RC224

Literature Affected: RC224 Modem Designer's Guide

errata sheet

Recommended Changes to the RC224 Modem Design

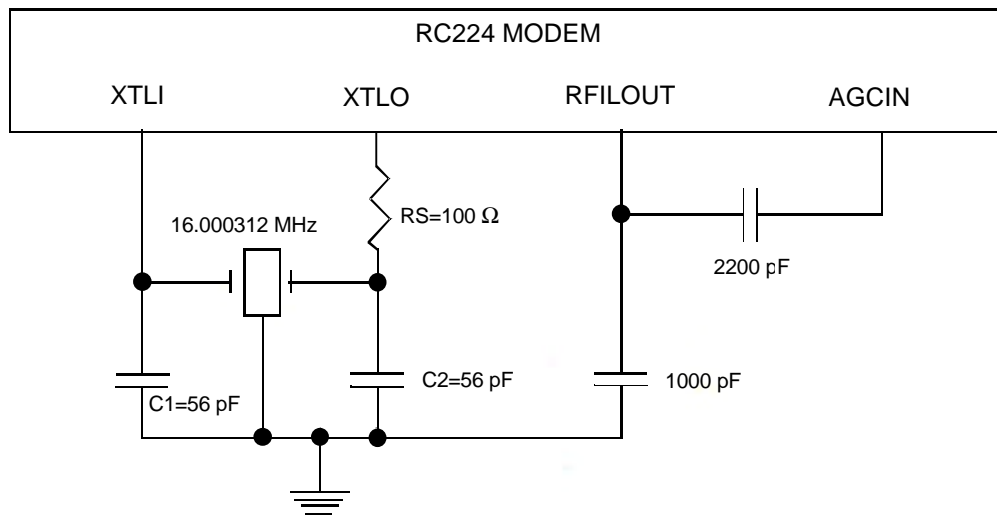
1) The CAP from RFILOUT to AGCIN must be 0.0022 uF (i.e. 2200 pF), NOT 0.1 uF that is shown in the Designer's Guide.

2) Upon completion of the crystal oscillator circuit evaluation, the following values for loading capacitor and series resistance are being recommended for use: C1=C2=56pF and Rs=100 ohms. It is critical that the series resistance Rs=100Ω is used in the oscillator circuit.
